BUILDING CODE OF AUSTRALIA COMPLIANCE ASSESSMENT REPORT

MAIN WORKS FOR WATERLOO MIXED USE DEVELOPMENT (HDA) - SSD-80441462

881-885 BOURKE STREET, WATERLOO – PARCEL 2 (BUILDINGS 2A & 2B) AND PARCEL 3
(BUILDINGS 3A & 3B)

REPORT NO. ► 13143.9-Rev 2

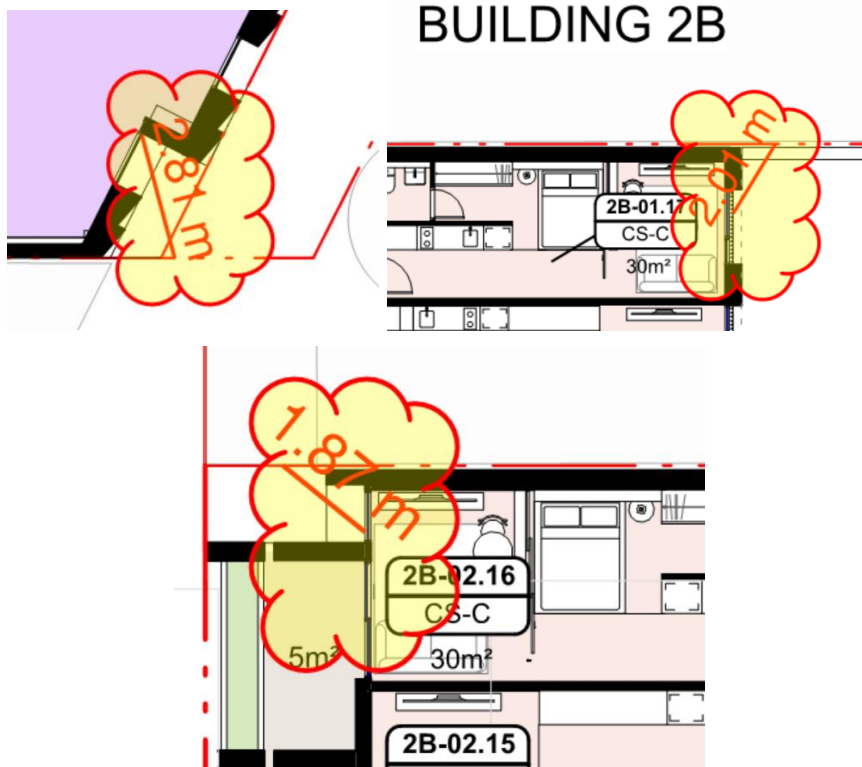
It should be noted fire separation will be required between ground floor and basement level 1 at the driveway due to the loading dock and waste room on the ground floor to Building 3A accounting for more than 10% of the floor area of the storey and Basement level 1 being classified as Class 7a (Carpark). In addition to this, fire separation between Basement 01 carpark and ground floor retail space. Fire separation is to be addressed by way of a Performance Solution by the fire engineer at CC stage.

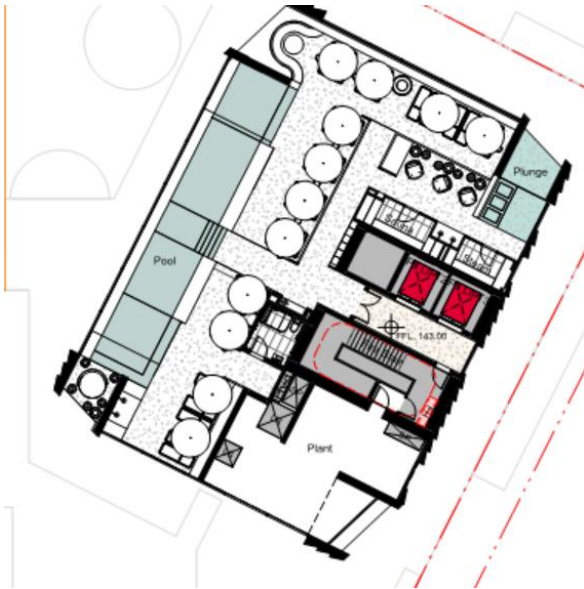
- There are numerous openings within 3m of boundaries that are noted as being dedicated as future roads. These roads will need to be dedicated as public roads or otherwise, the openings within 3m of these boundaries will need to be protected in accordance with Clause C4D5 or addressed by way of a Performance Solution by the fire engineer at CC stage. Examples of the openings within to potentially be protected are clouded in yellow below.

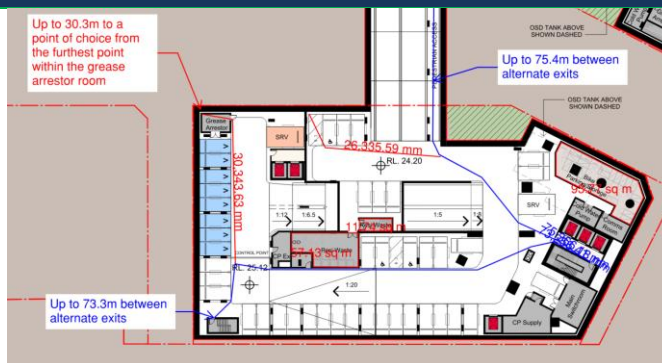
- Basement 01 – Up to 32.4m to a point of choice in lieu of 20m from the furthest point within the CP Supply room;

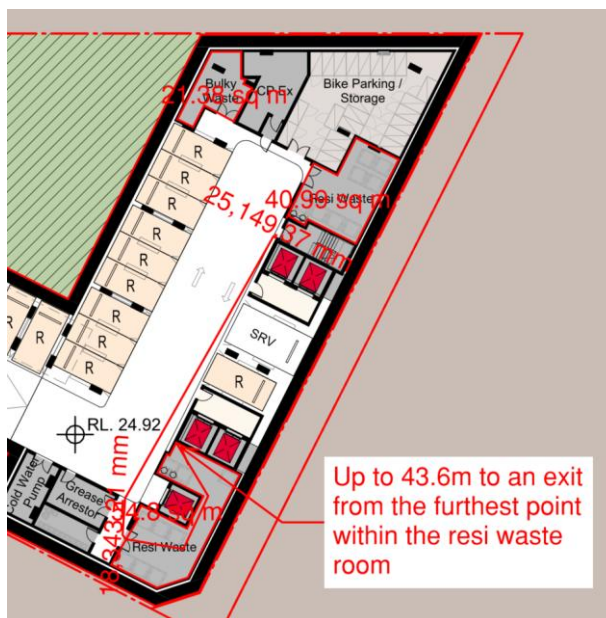
- Basement 01 – Up to 32.4m to a point of choice in lieu of 20m from the furthest point within the grease arrestor room;

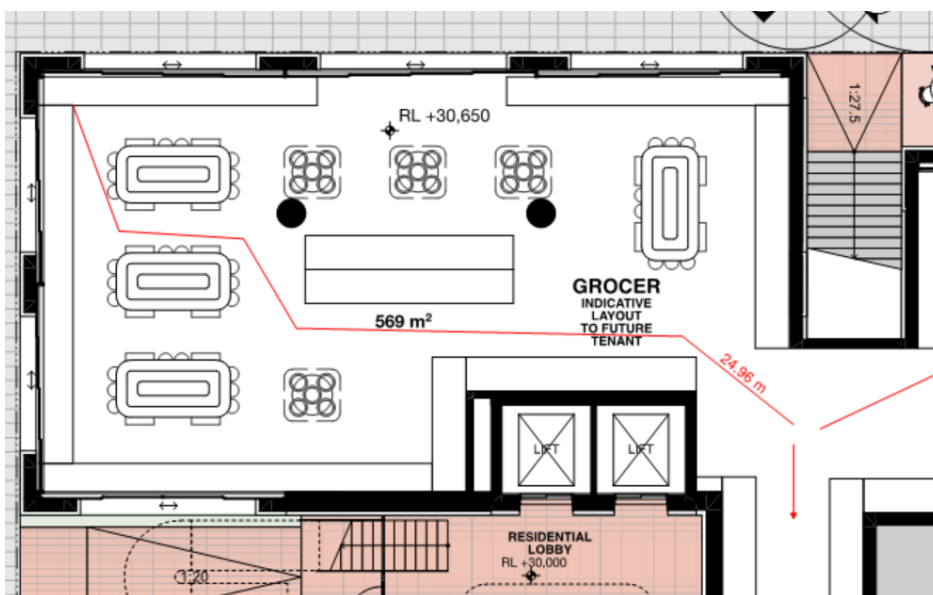
- Basement 01 – Up to 43.6m to an exit in lieu of 40m from the furthest point within the Resi waste room;

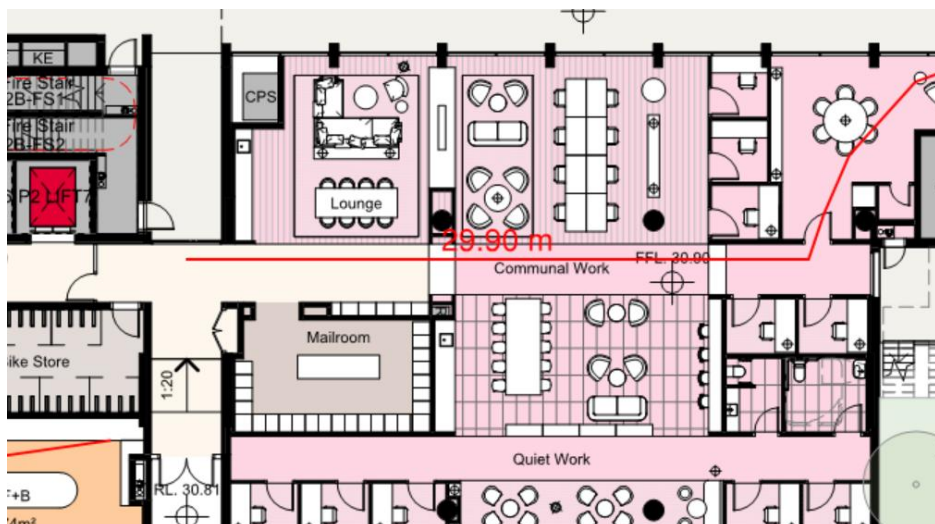
- Ground floor retail tenancy (Building 3B) – 25m to a point of choice to 2 exits in lieu of 20m;

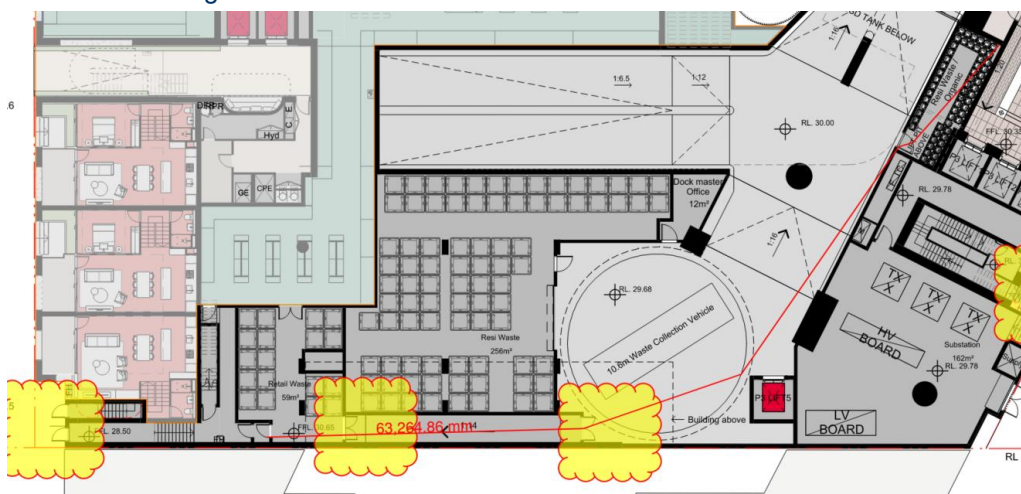
- Ground floor communal work area (Building 2B) – 30m to a point of choice to 2 exits in lieu of 20m;

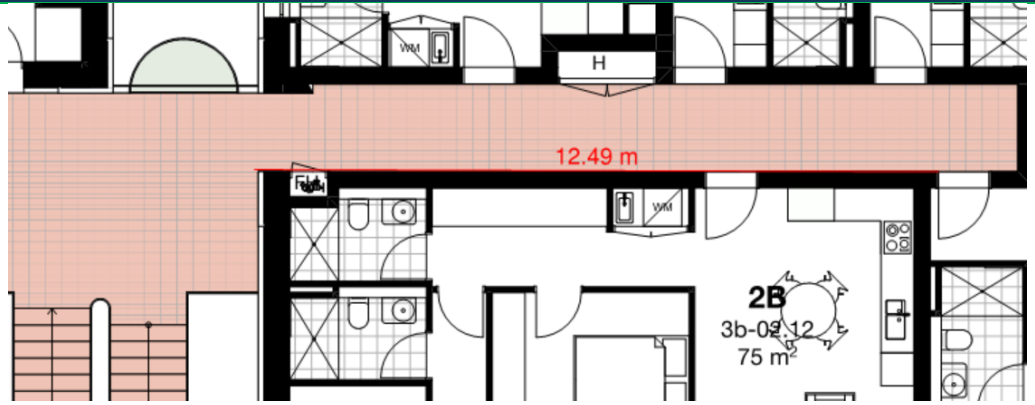
- Level 04 to level 07 and level 08 to level 13 (Building 2B) – Up to 6.7m to a point of choice to 2 exits in lieu of 6m;

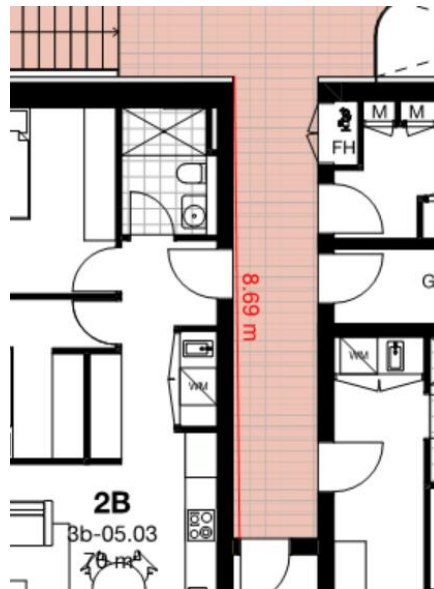
- Level 01 to level 6 (Building 2A) – Up to 9m and 10.5m to an exit in lieu of 6m from the doorway to the furthest unit;

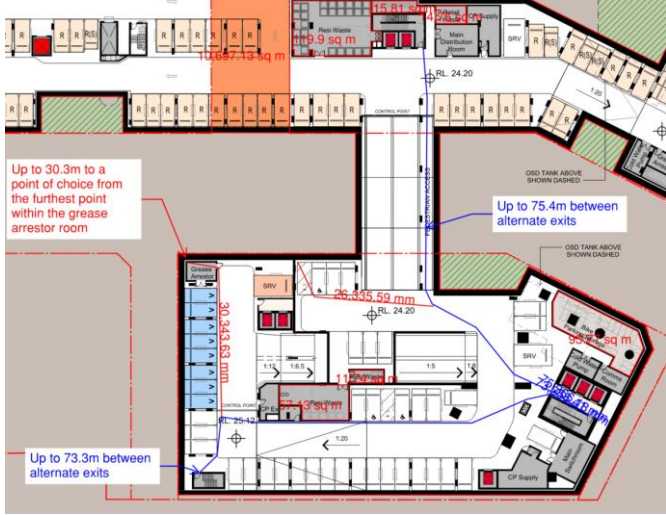
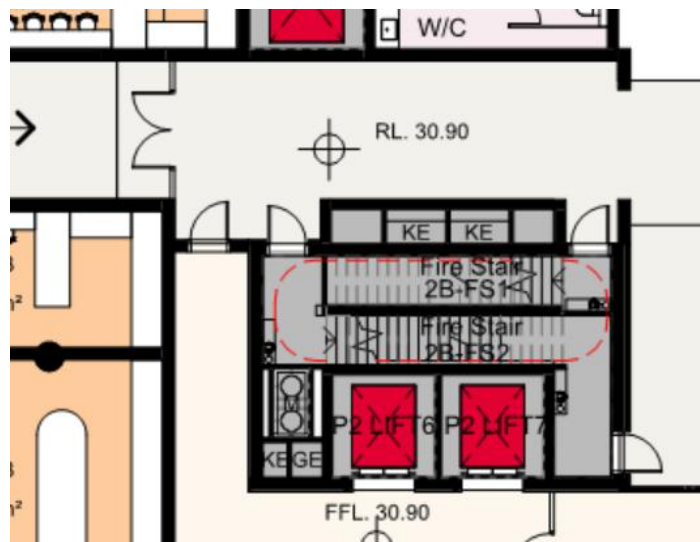
- Level 03 and 04 (Building 3A) – Up to 6.4m to a point of choice to 2 exits in lieu of 6m;

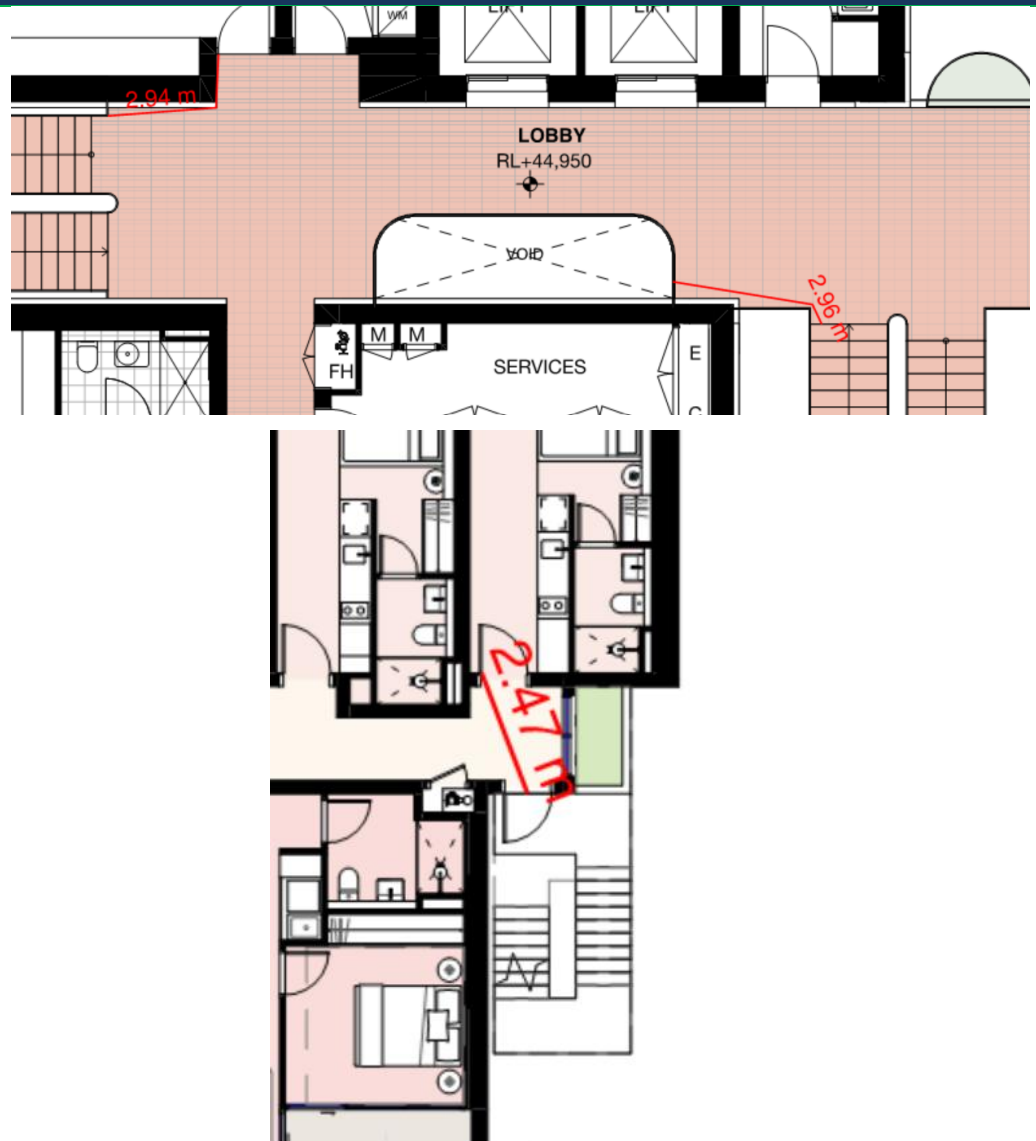
- Level 06 (Building 3A) – Up to 34.3m from the furthest point on the external balcony of the communal area in lieu of 20m;

This is to be addressed by way of a Performance Solution by the fire engineer at CC stage.

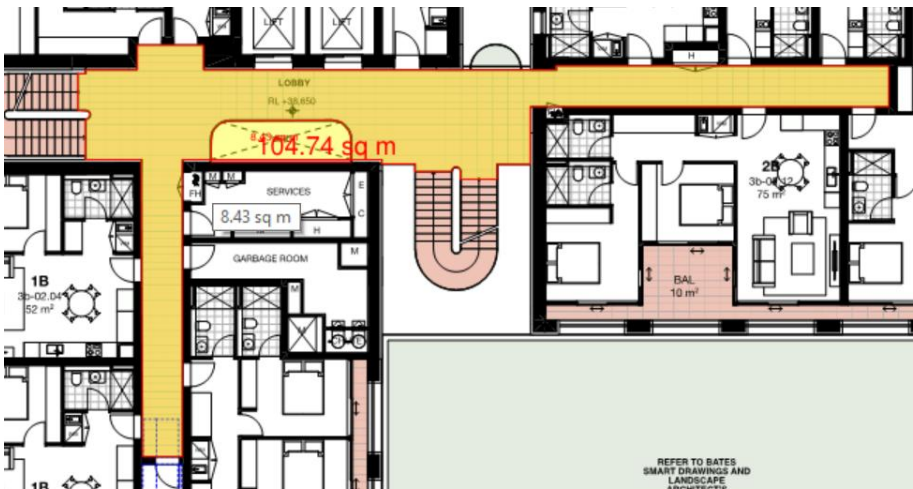
- The external non-fire-isolated stairways serving in lieu of fire-isolated discharge into a covered area on level 1 and then use a separate non-fire-isolated stairway to discharge to the street at ground level and requires occupants to pass by openings in the external wall. Discussions to be held with the fire engineer to determine if this can be addressed by way of a Performance Solution.
